Addendum

DATE: 12/22/2023

PROJECT: 614, 624 & 702 Building Renovation and
Addition
East End Community Services / West Care

ADDENDUM NO. 1

SHEET NO.
A7.1

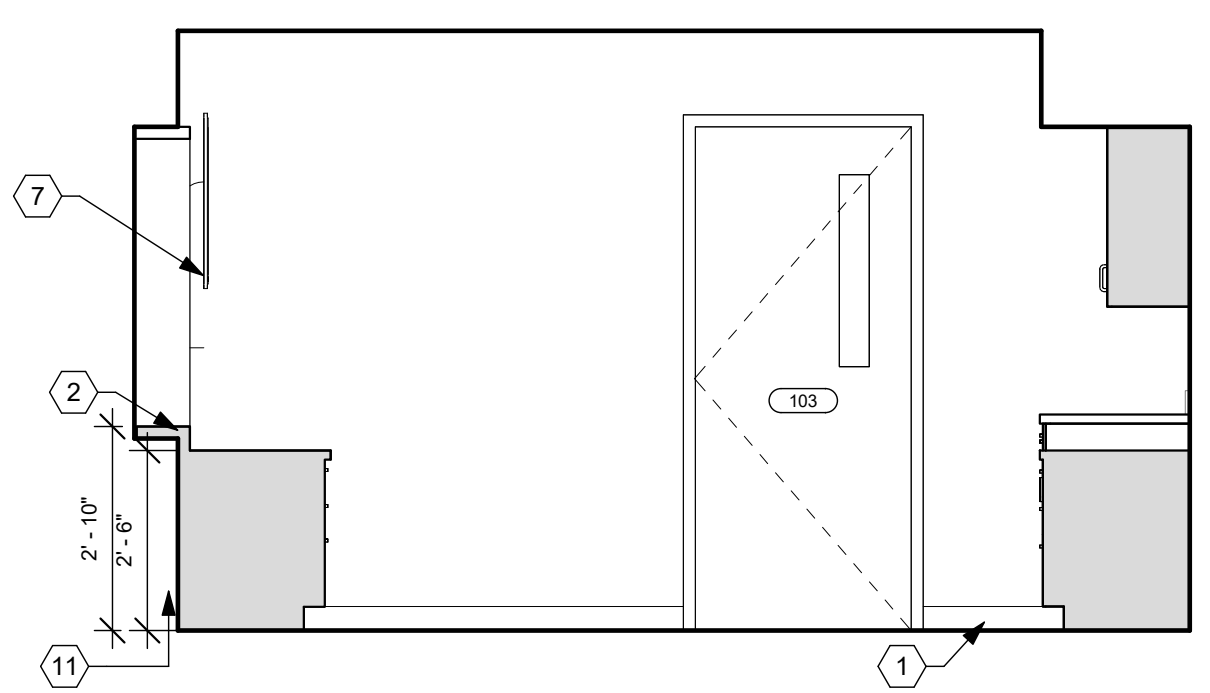
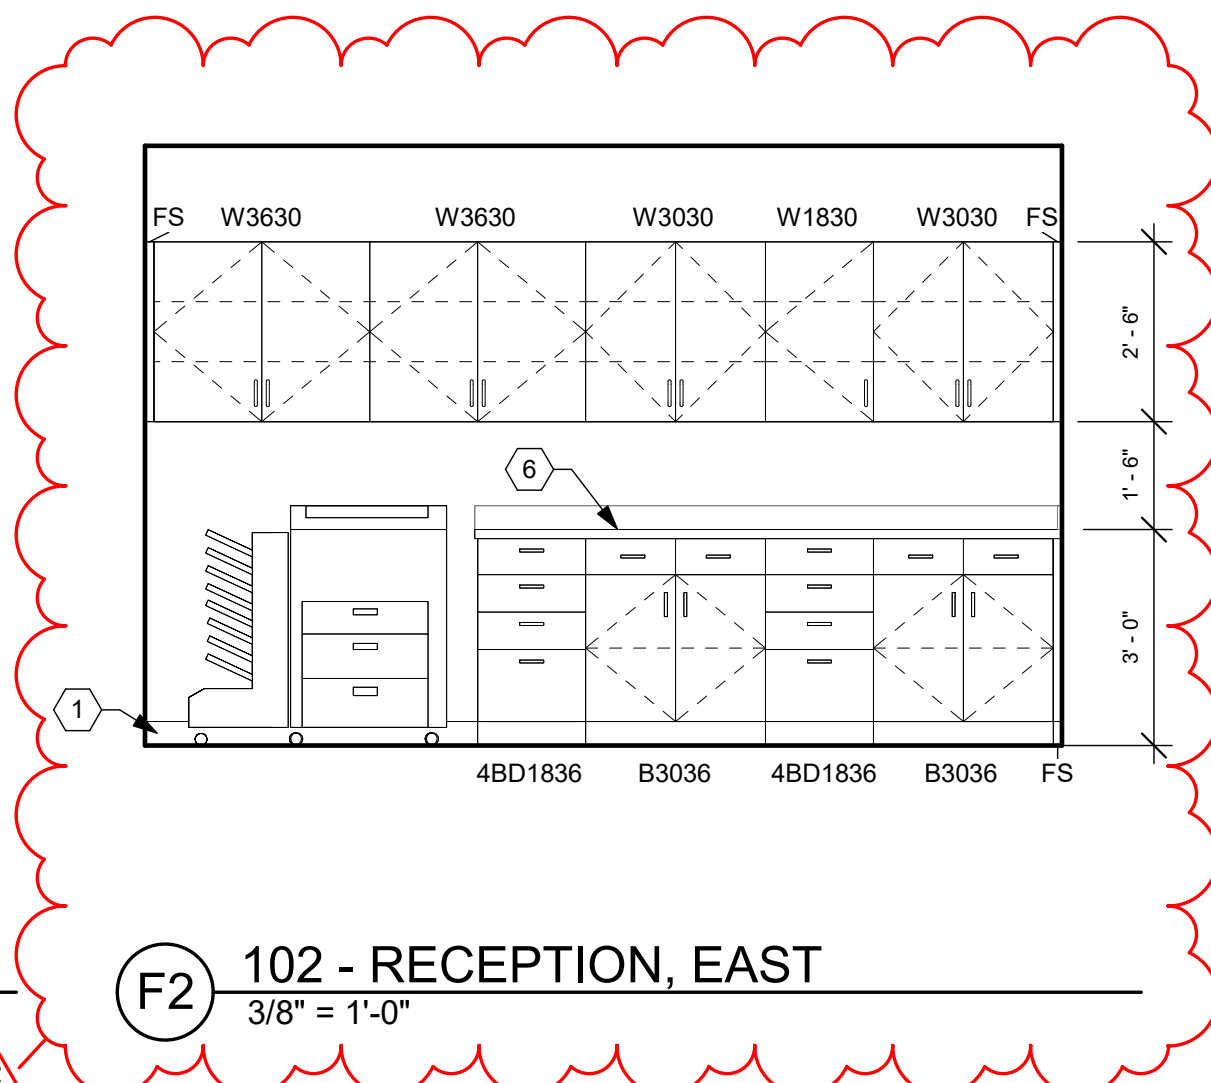
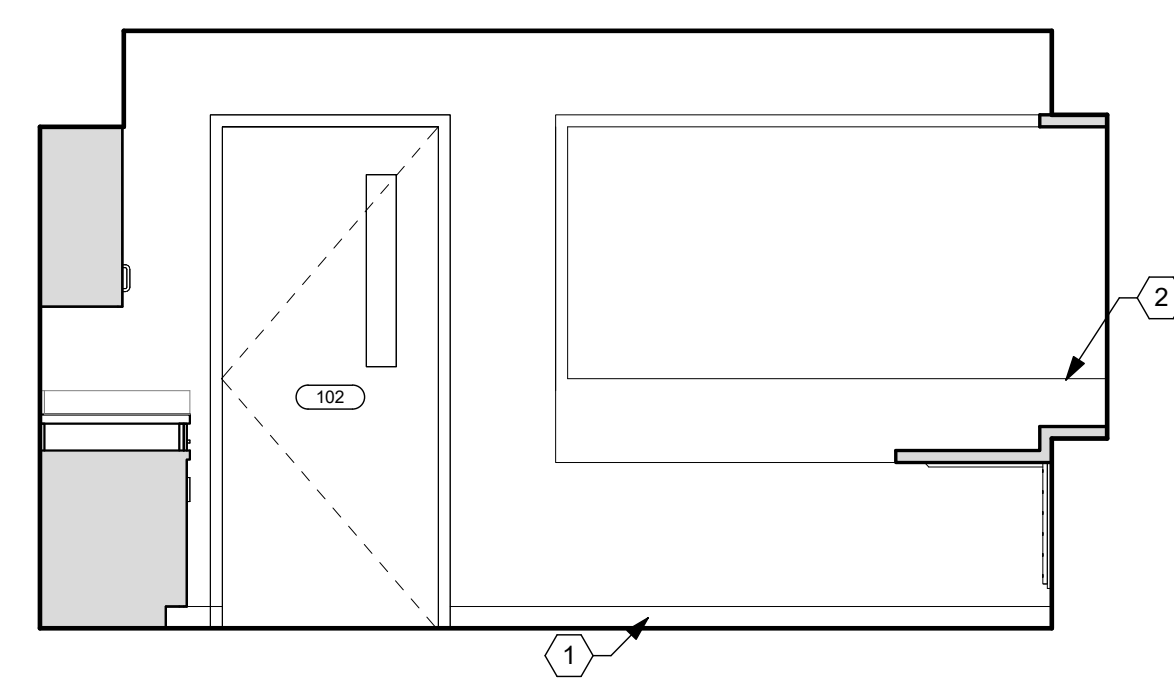
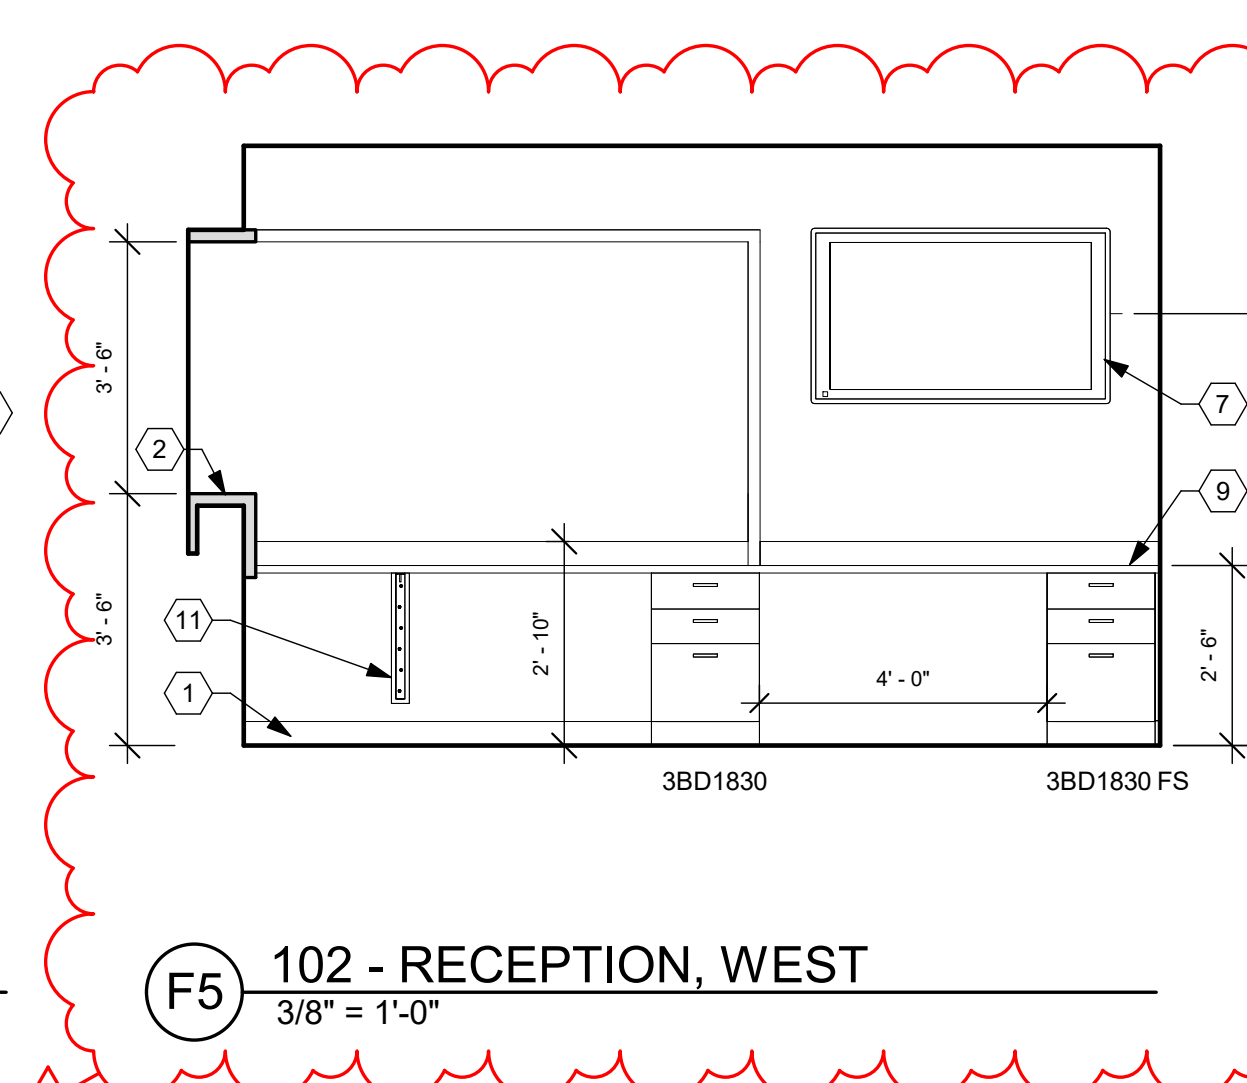
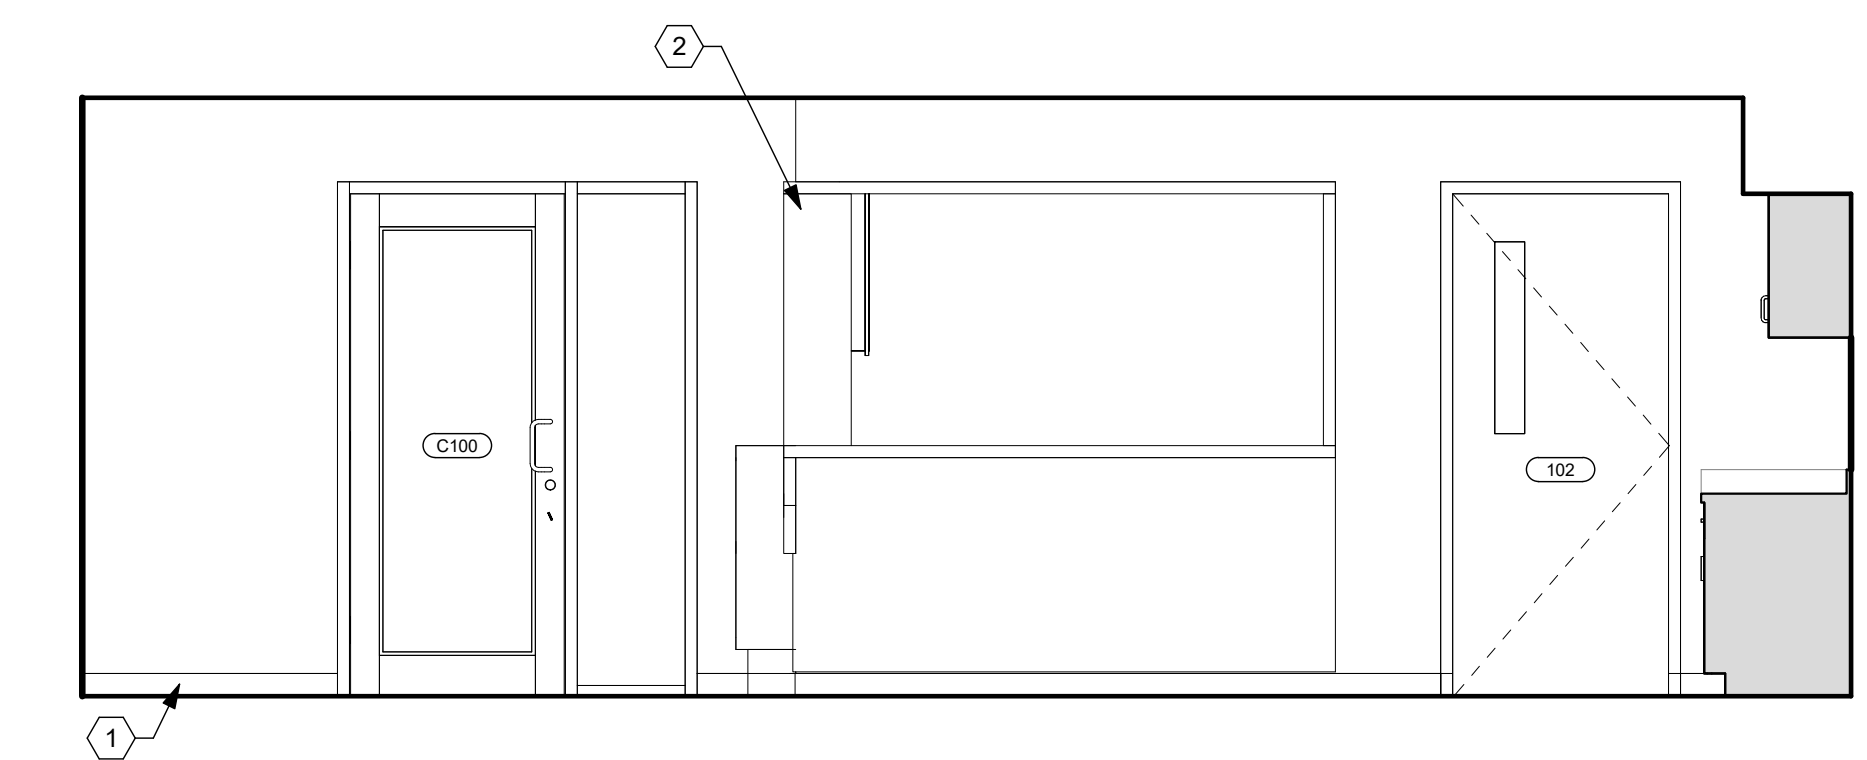
- ITEM A1 SHEET A0.3 – DOOR & FRAME SCHEDULES (624 Building)
 1. Doors 150 & 201A revised to 2'-0" wide doors.
- ITEM A2 SHEET A1.3 – FIRST FLOOR DIMENSION PLAN (624 Building)
 SHEET A1.6 – SECOND FLOOR DIMENSION PLAN (624 Building)
 1. Elevator shaft dimensions revised.
 2. Doors E100 & E200 locations revised.
 3. Doors 150 & 201A revised to 2'-0" wide doors.
- ITEM A3 SHEET A7.1 – INTERIOR ELEVATIONS (624 Building)
 1. Casework revised in Room 102 Receptionist.

SHEET NO.
E1.1

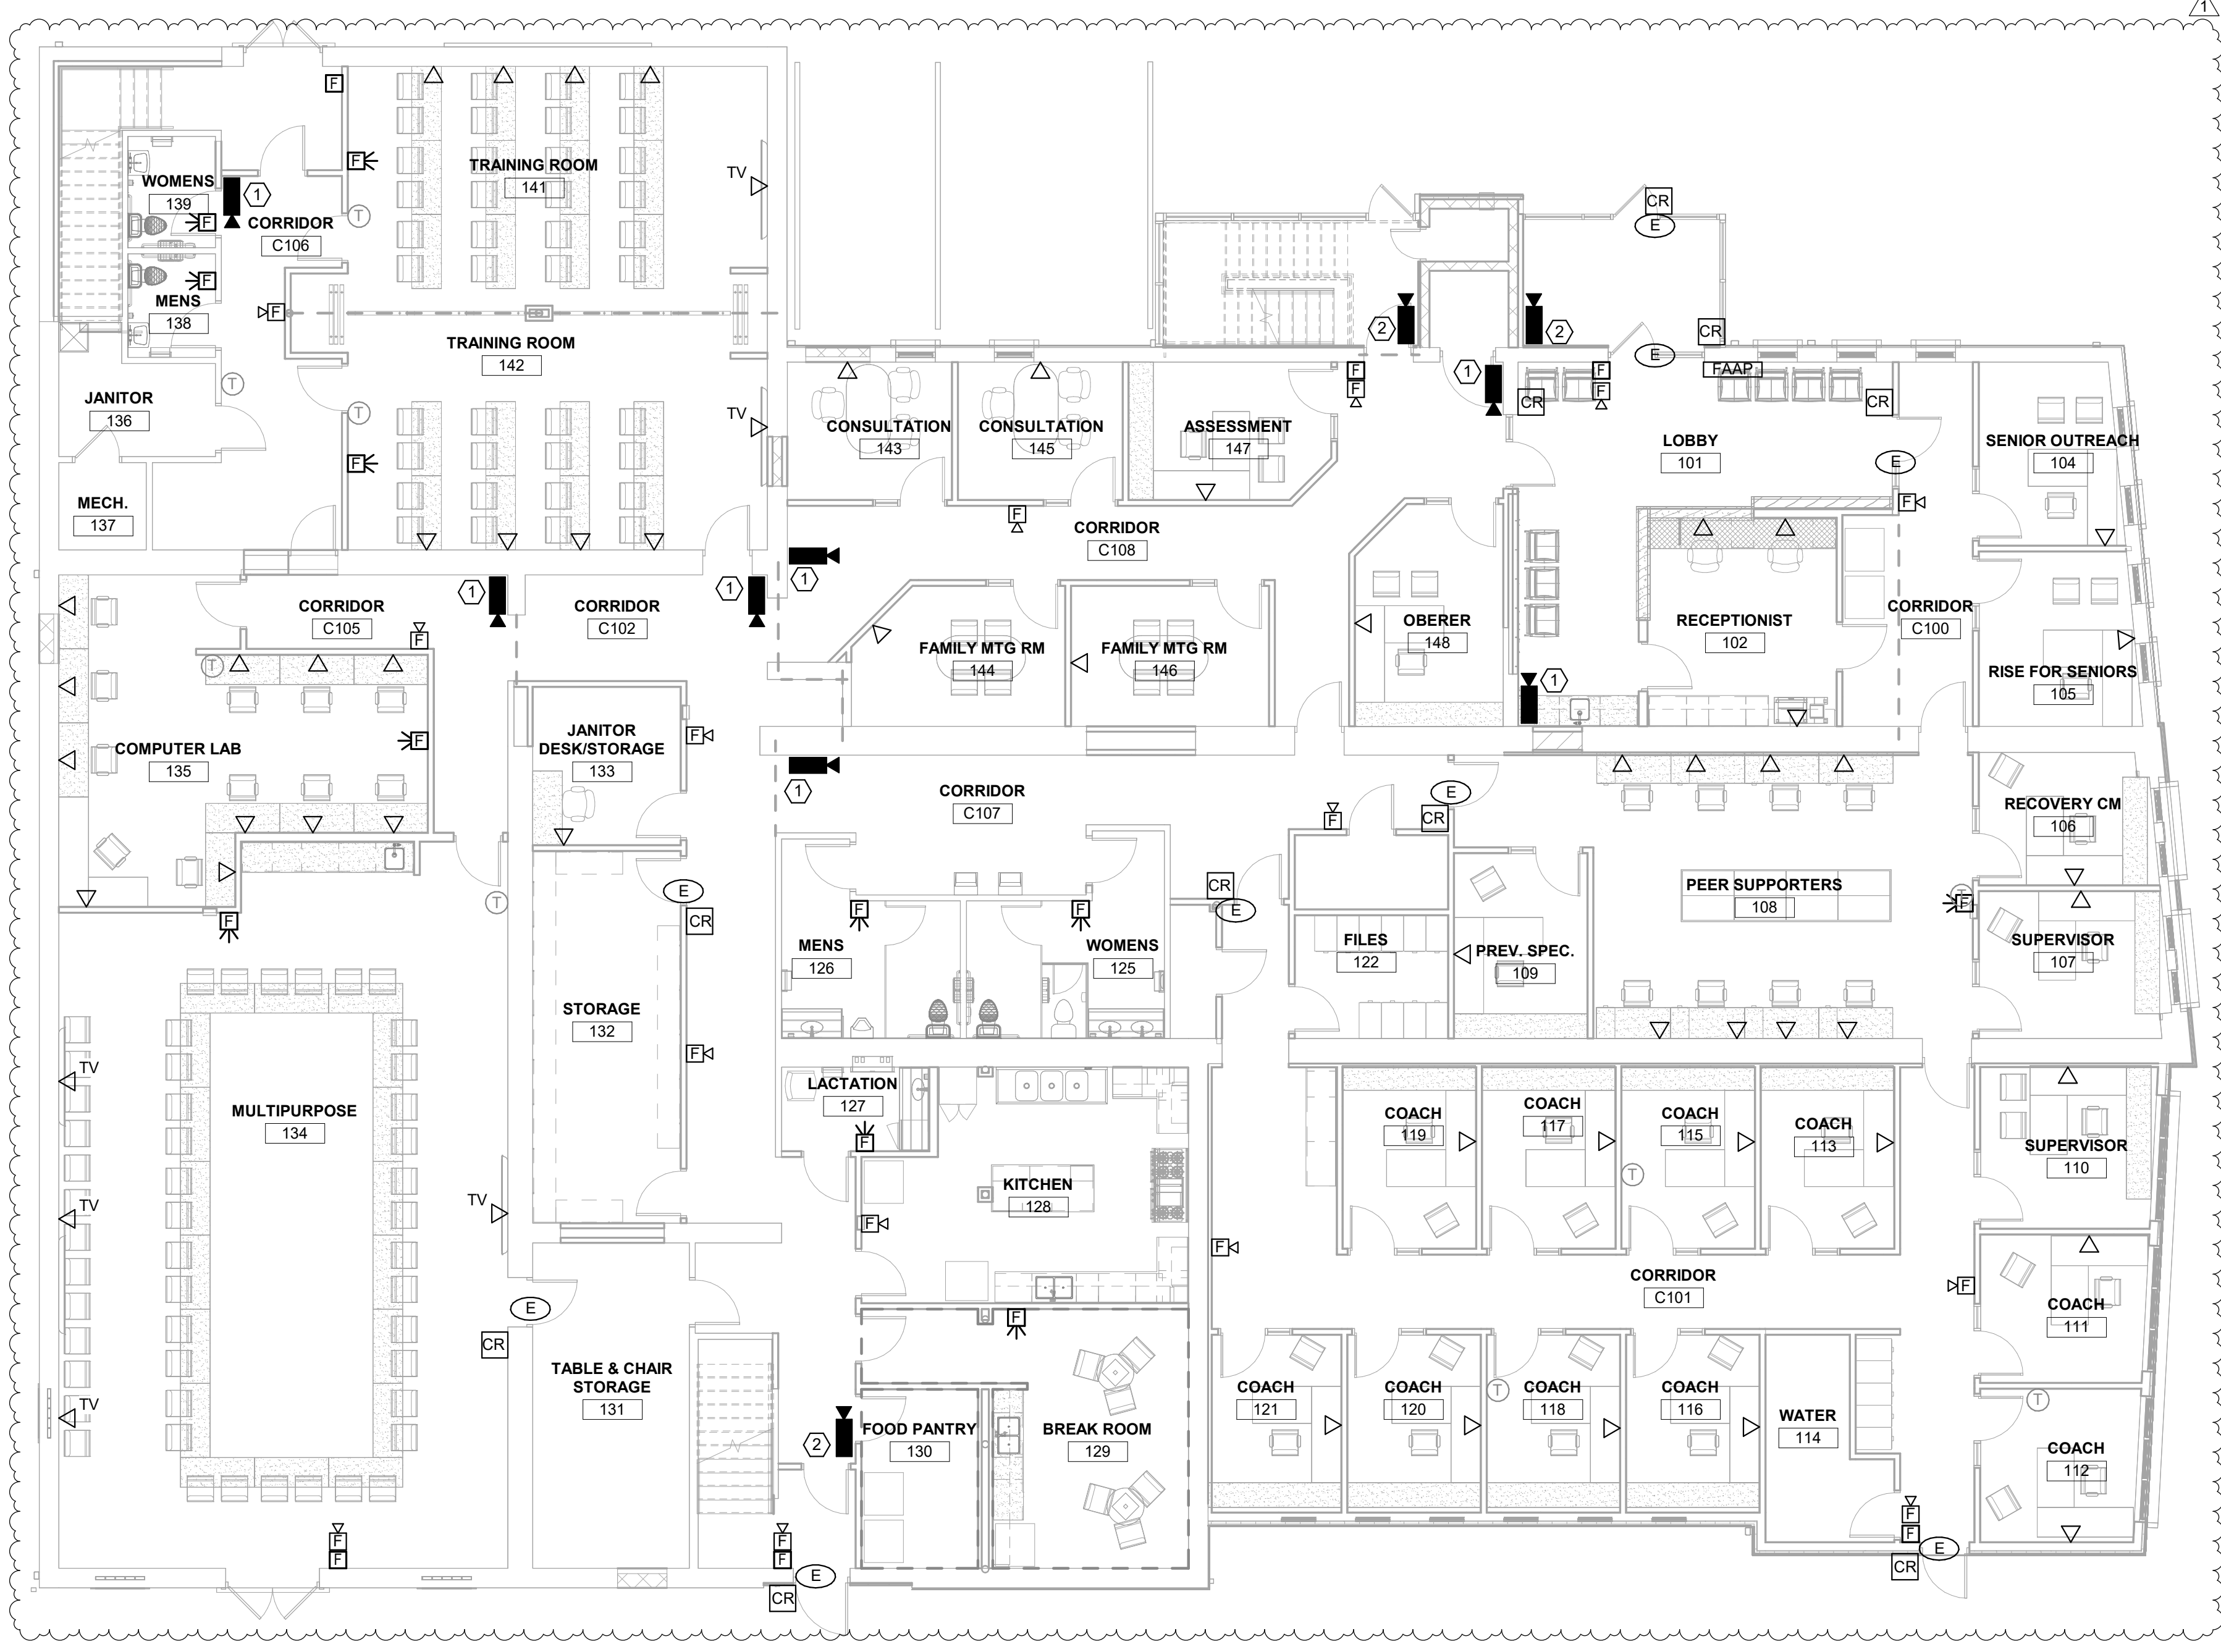
- ITEM E1 SHEET E1.1 – ELECTRICAL POWER PLAN (624 Building)
 1. Power revised at Room 102 Receptionist.
- ITEM E2 SHEET E3.1 – ELECTRICAL SYSTEMS PLAN (624 Building)
 1. Sheet revised to show data devices.
